VIRGINIA ELECTRIC AND POWER COMPANY  
RICHMOND, VIRGINIA 23261

Serial No. 725A  
NO/WLT/JOE:ms  
Docket No. 60-338  
License No. NPF-4

REQUEST FOR ADDITIONAL INFORMATION  
ELECTRICAL DISTRIBUTION SYSTEM VOLTAGES  
NORTH ANNA POWER STATION

SERIAL NO. 725A

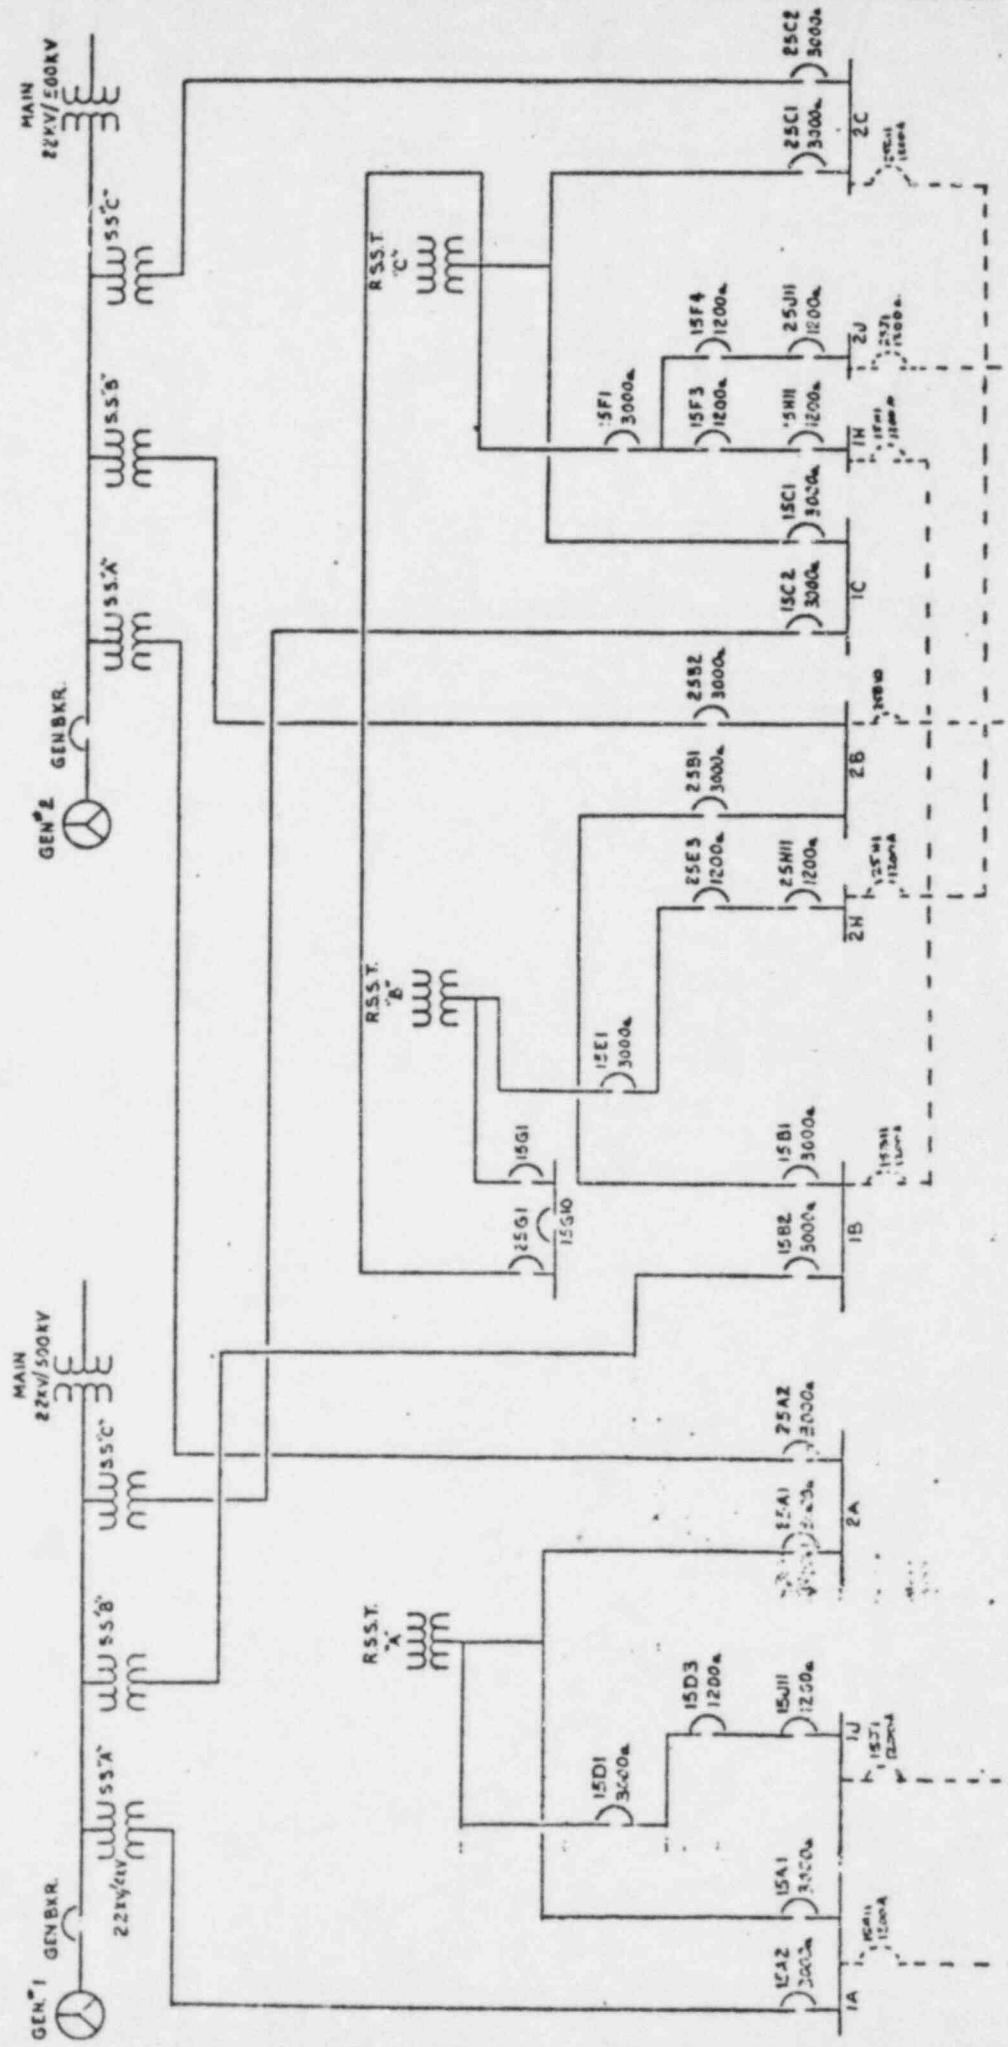
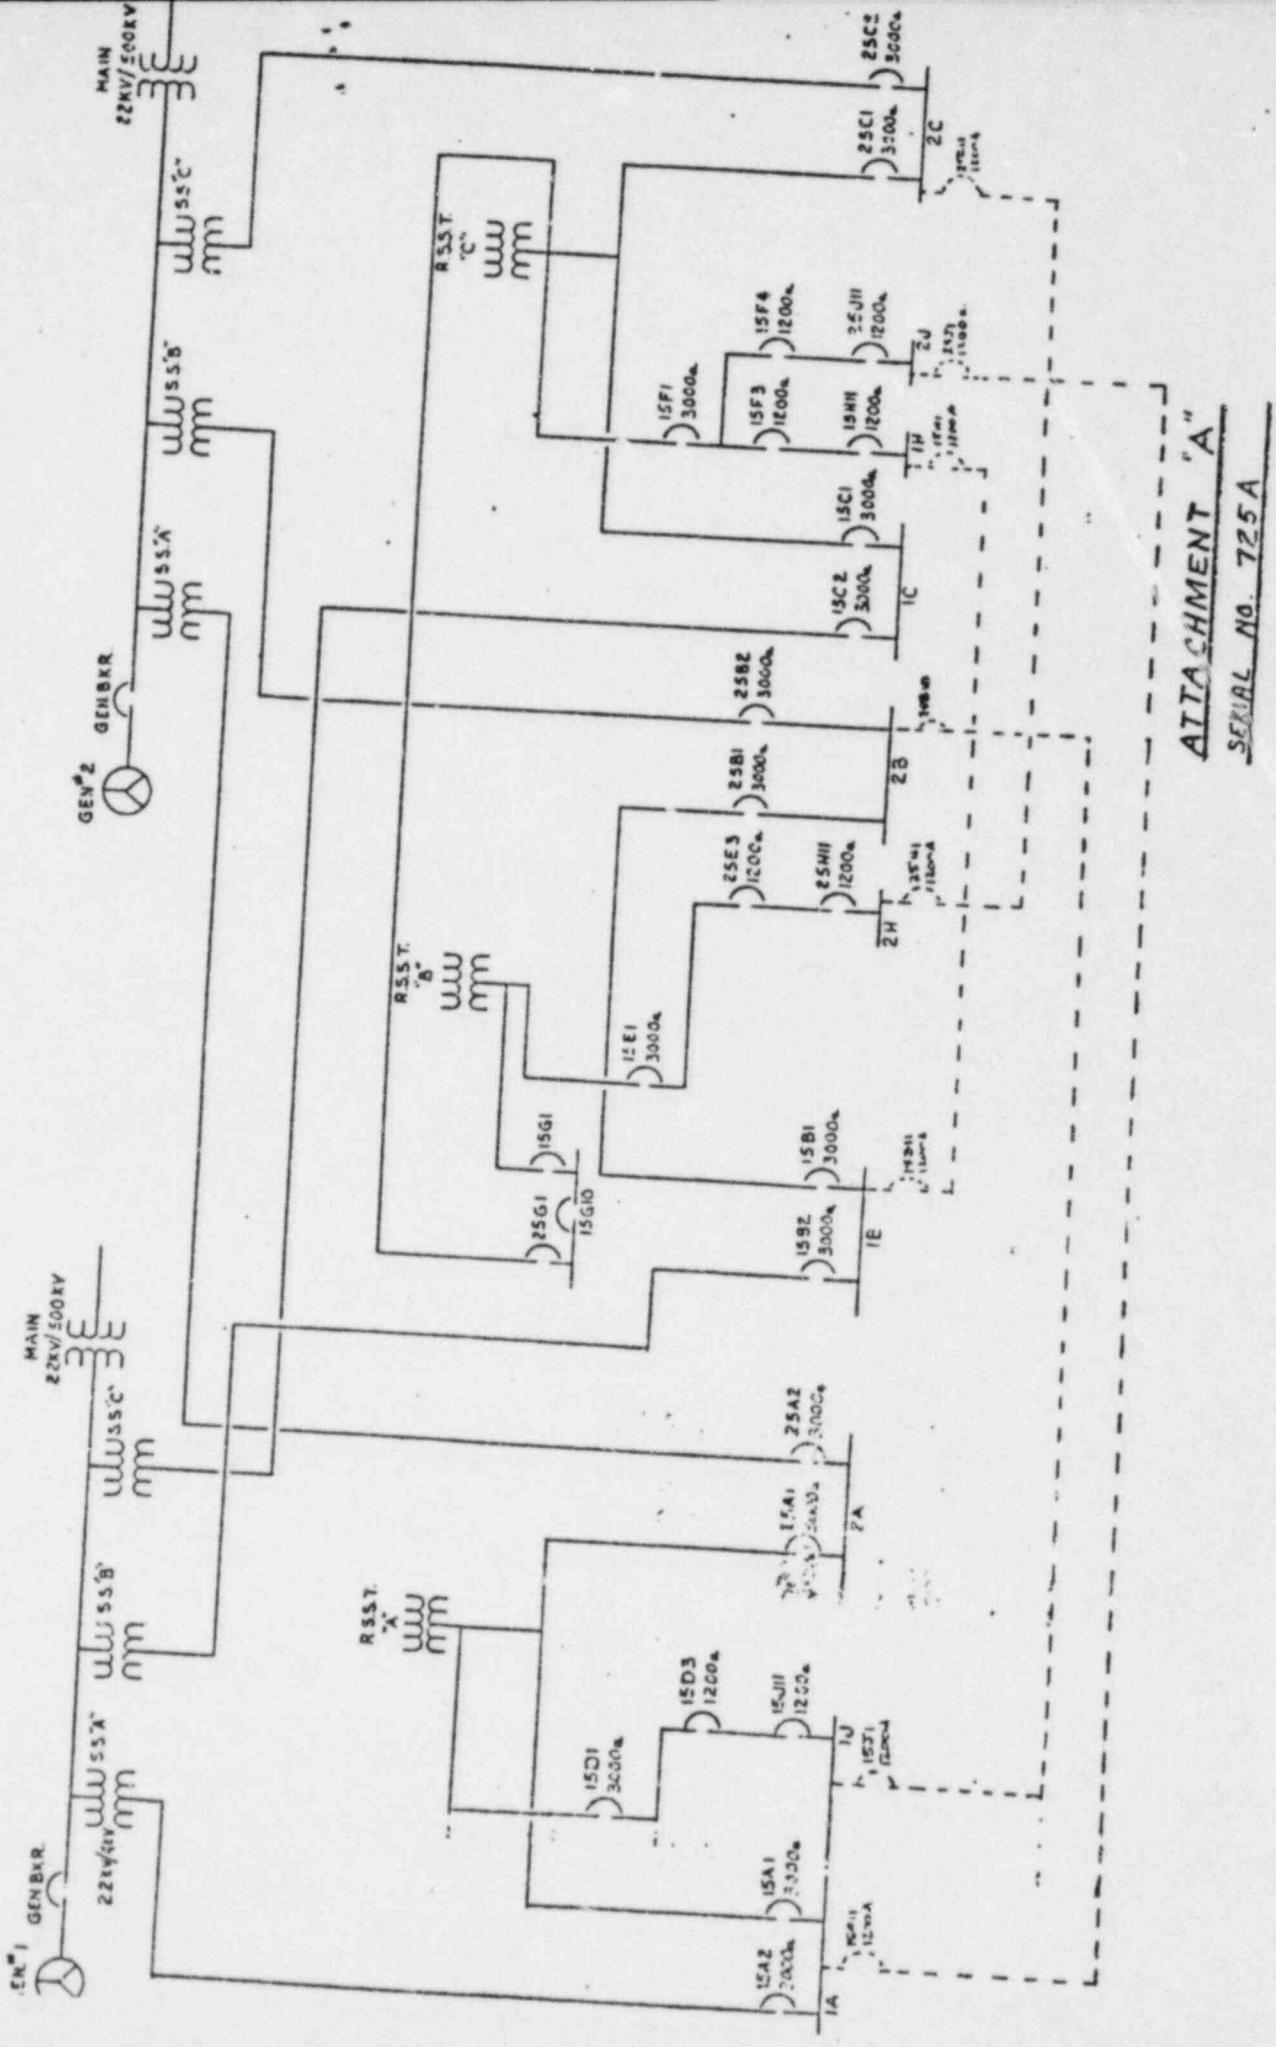
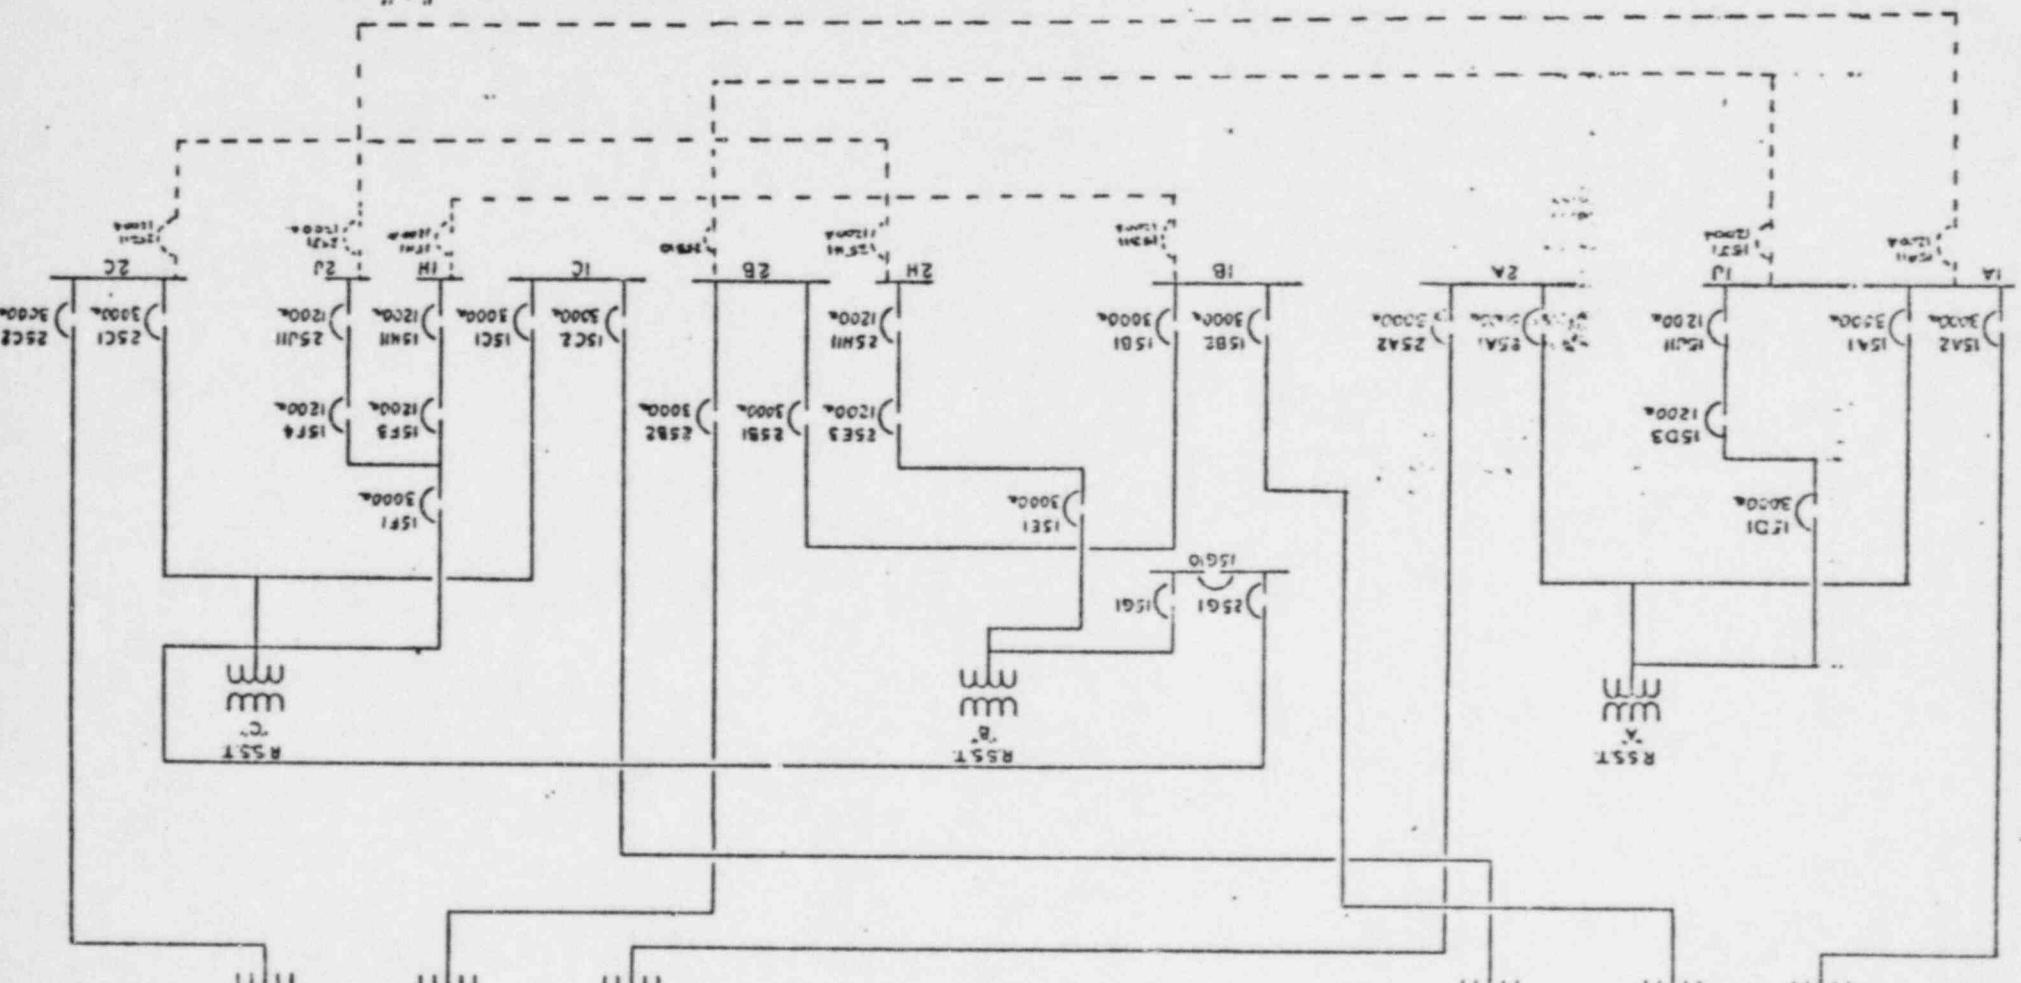
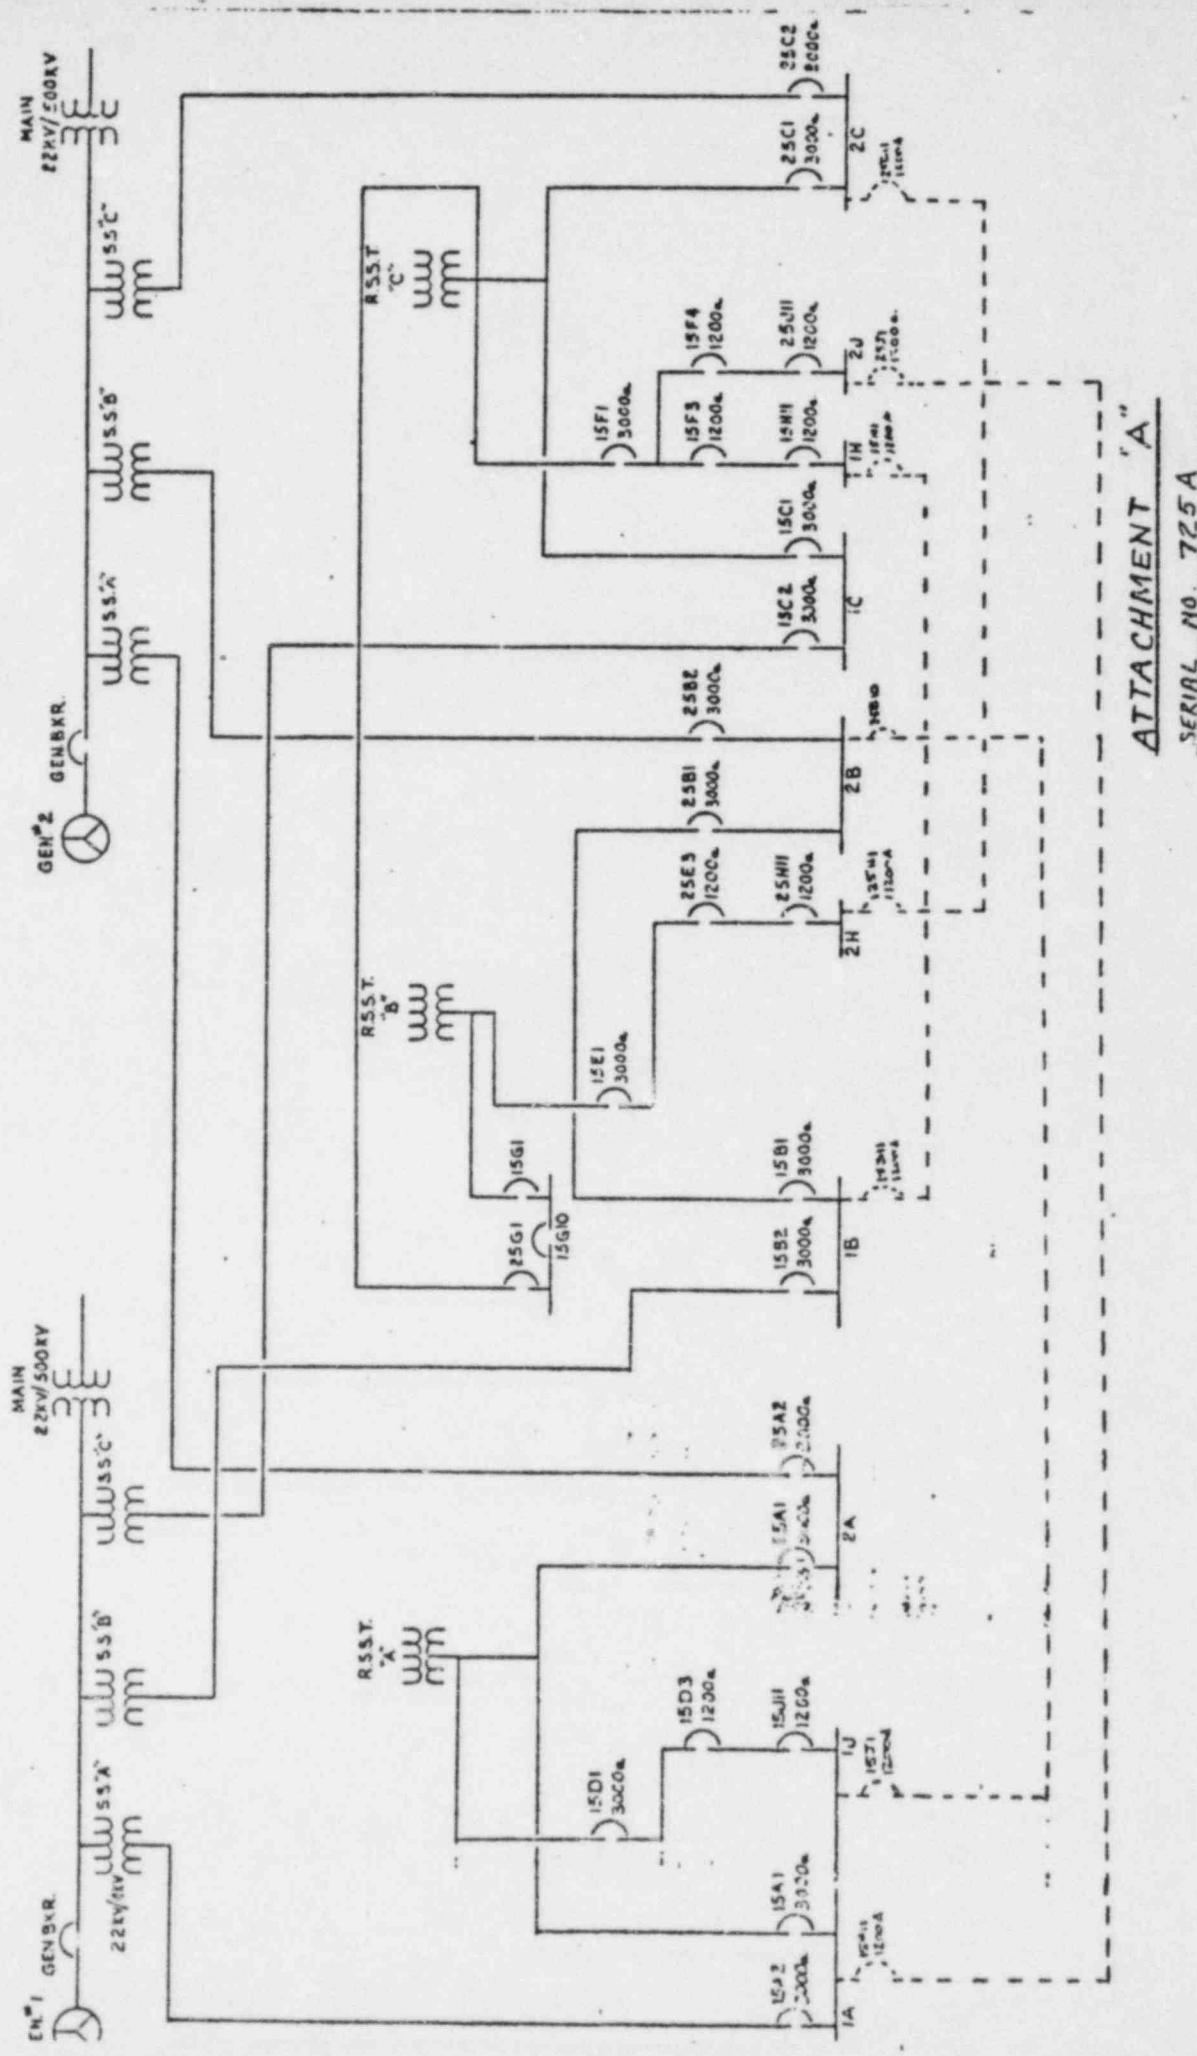
Our analysis has shown that the installation of circuit breakers between the generator and the station service transformers will provide tremendous flexibility and capability in offsite power supplies. Attachment A to this letter is a one-line diagram of our planned future system. This arrangement will allow unit start-up with auxiliaries powered through the normal station service transformers. It will also curtail the need to transfer auxiliary loads to the reserve transformers for most unit trips. Therefore, it will be inconceivable that the loading on the reserve system could ever approach the postulated values in our previous studies.

One additional benefit of the generator breaker would be that it provides an additional offsite power supply through the main transformer and the station service transformers. By installing a generator breaker in each unit at North Anna, we will have four independent power supplies from the 500KV bus to the two units' auxiliaries. This advantage will be utilized by providing an alternate tie to each 4KV emergency bus from a normal station service bus.

The design for the modifications discussed above for North Anna Units 1 and 2 is proceeding. Installation will occur at the earliest practical date. Further information on this modification will be forwarded to you in a later submittal.
